DEPARTMENT OF INDUSTRIAL RELATIONS
DIVISION OF OCCUPATIONAL SAFETY AND HEALTH
Headquarters Office
1515 Clay Street, Suite 1901
Oakland, CA 94612
(510) 286-7000 Fax: (510) 286-7037

Re: Title 8 Section 1715 Tilt-Up Concrete Panel Construction

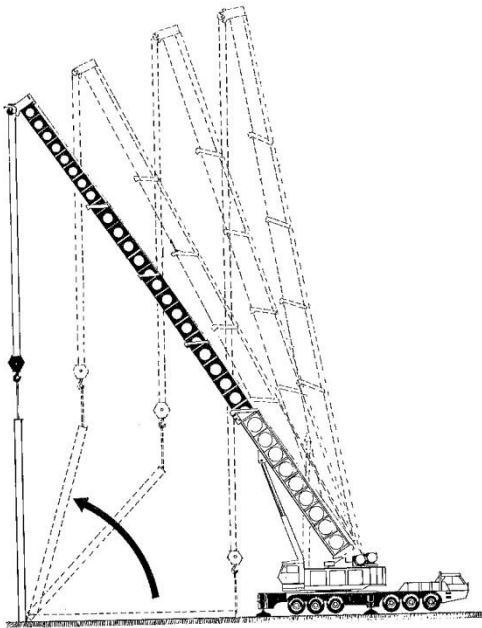
The photograph you provided and shown to the right is an example of a crane which is directly under the tilt-up panel load in violation of 1616.4(e)(1) and in violation of 1715(d)(5) because it puts an employee (crane operator) at risk of being struck by the panel. If the panel were to fall and strike the crane, it is also likely that the crane would collapse and strike other nearby workers in the fall zone.

The illustration and picture below shows methods of lifting a tilt-up panel without putting the crane and crane operator directly under the tilt-up load. The crane can be located outside the direct drop zone of the panel as shown in the illustration or the crane can be off to the side and out of the drop zone of the panel as shown in the photograph.
